ITEM FOR ENVIRONMENTAL COMMISSION AGENDA

NAME & NUMBER OF PROJECT: The Holdsworth Center SPC-2017-0513C

REQUEST: Variance request is as follows:
 1. Fill exceeding four feet in depth in DWPZ, not to exceed 10
 feet.

Staff Findings of Fact and Exhibits

EXHIBIT 1

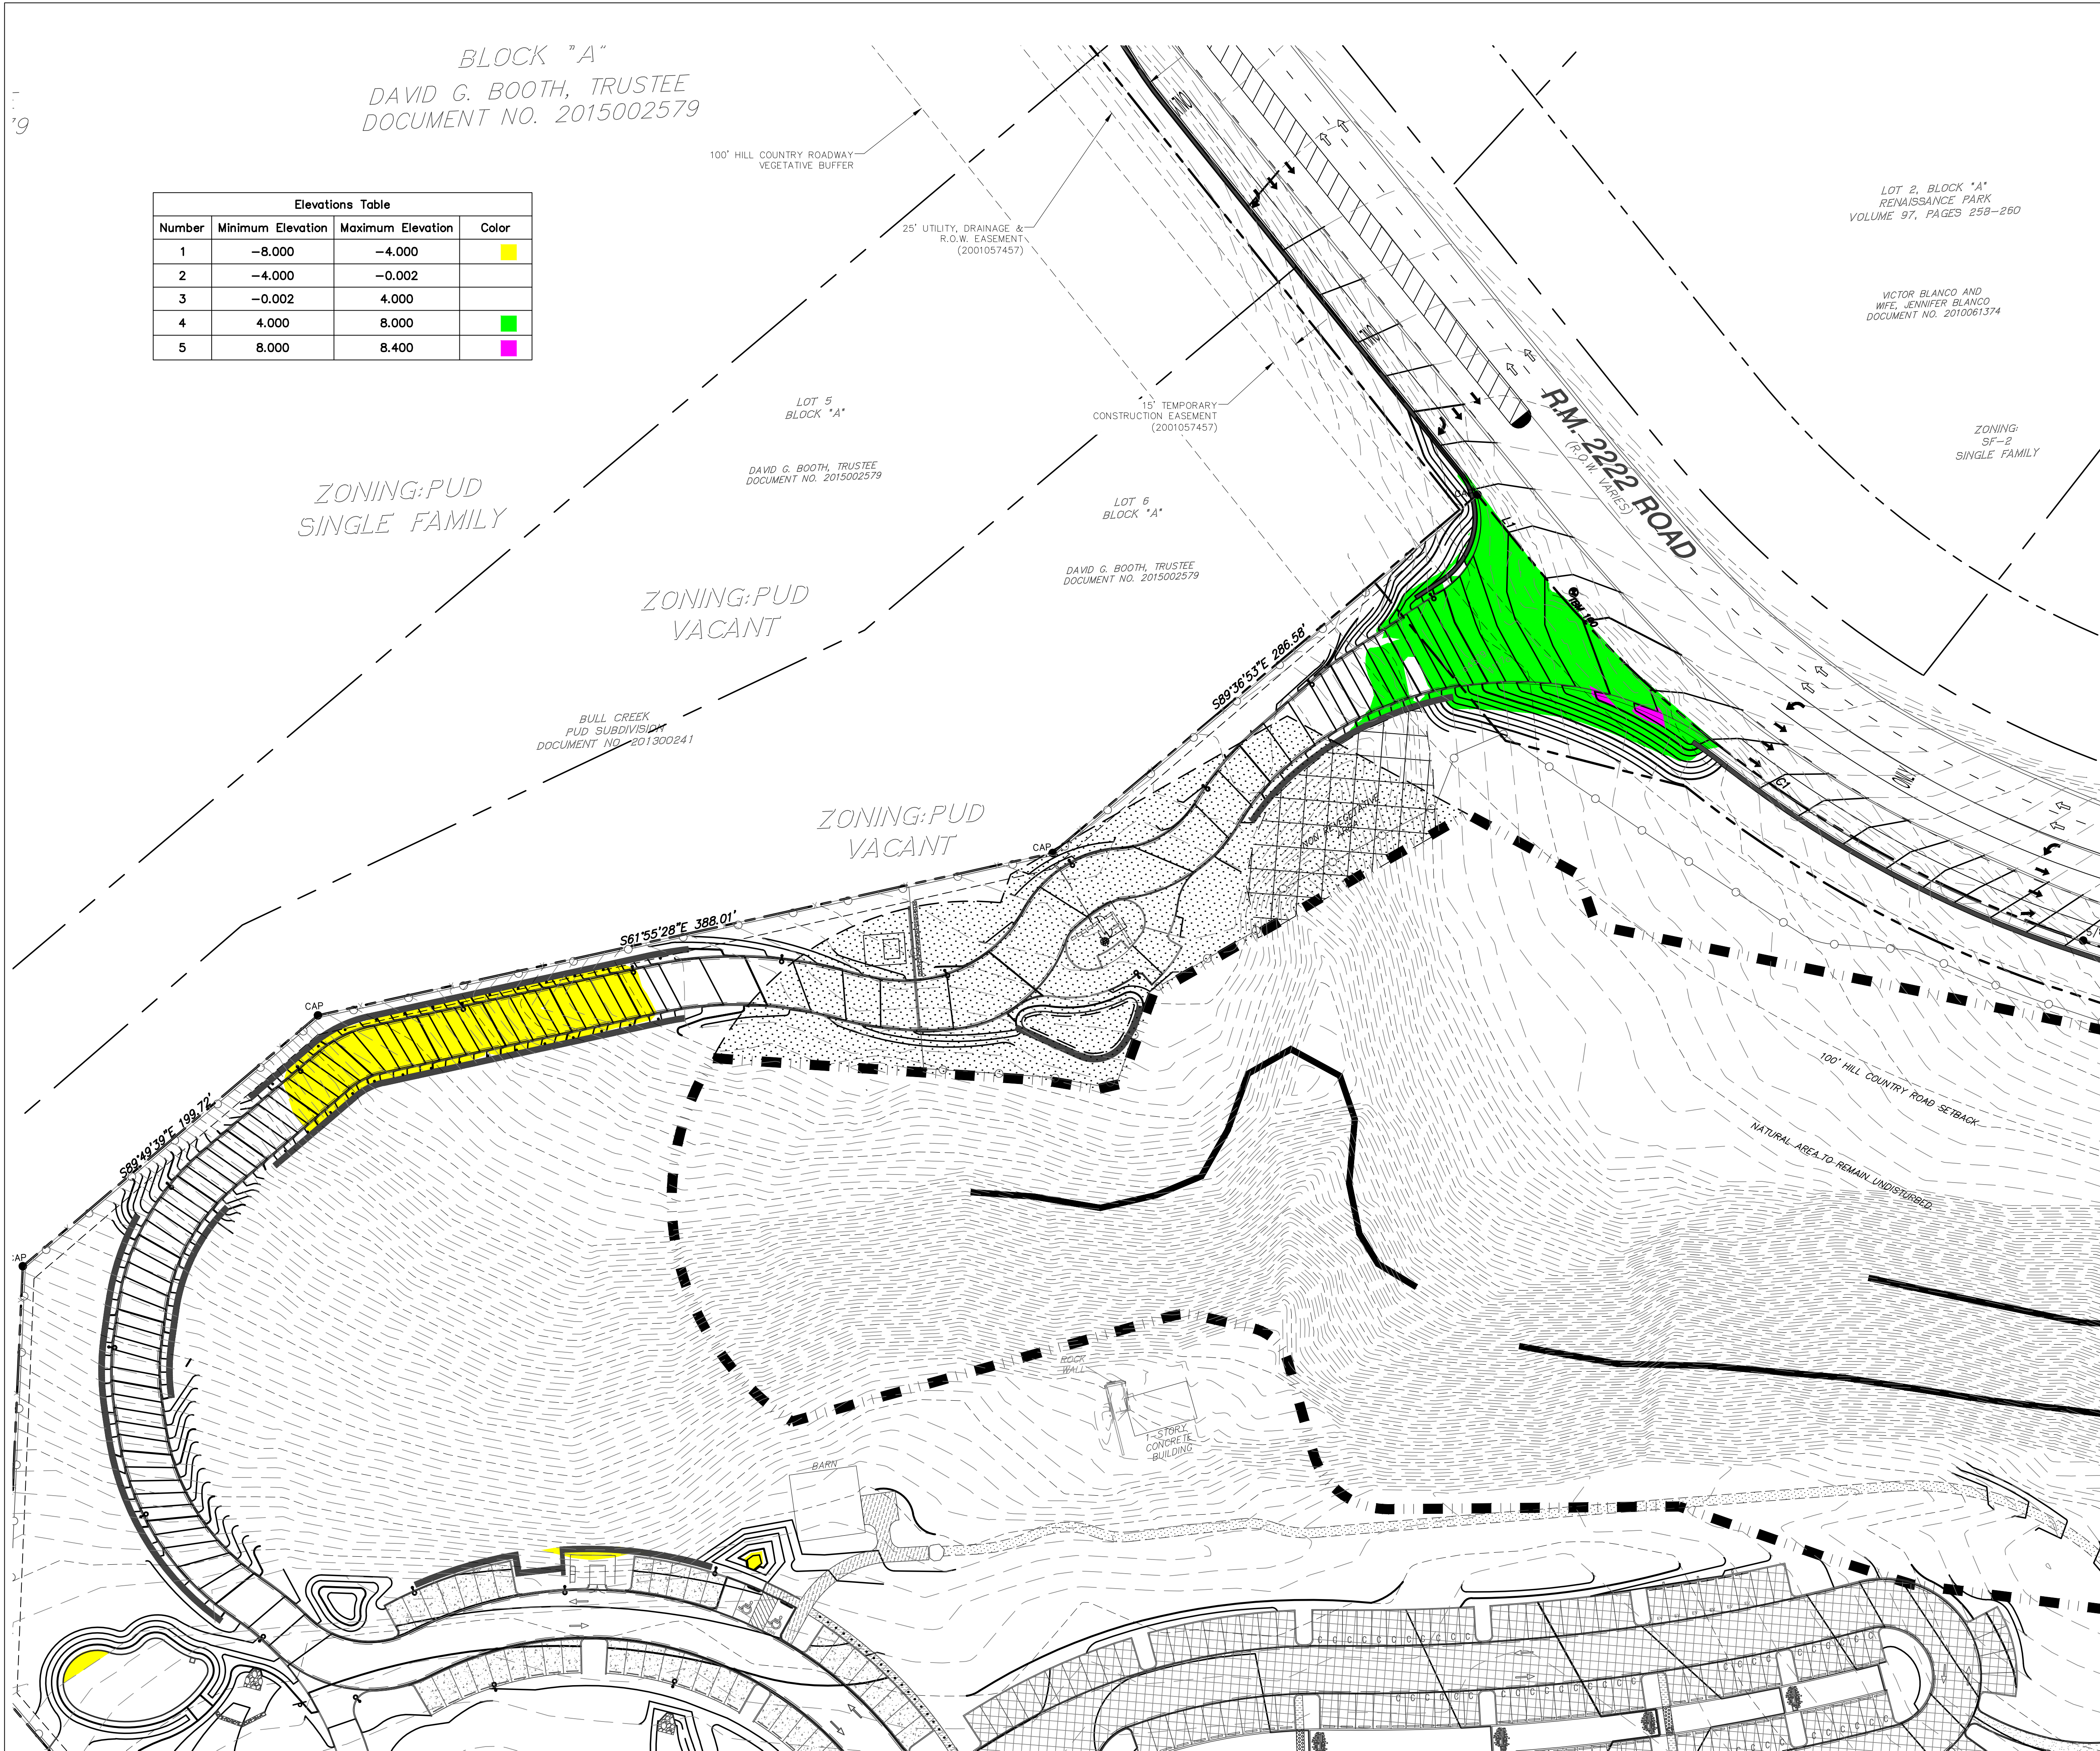
Yes. The entry drive is designed in such a way to reduce the amount of fill required to the least extent possible while still maintaining safe ingress/egress to the site (see Exhibit 1).

Yes. The extra fill is proposed outside the ½ critical root zones of protected trees and will be structurally contained using retaining walls.

Staff recommends approval of the requested variance with the following conditions:

- The extra fill must be outside the ½ critical root zones of protected trees and be structurally contained using retaining walls.
- The structural containment must be constructed prior to construction of the fill associated with the need for the variance.
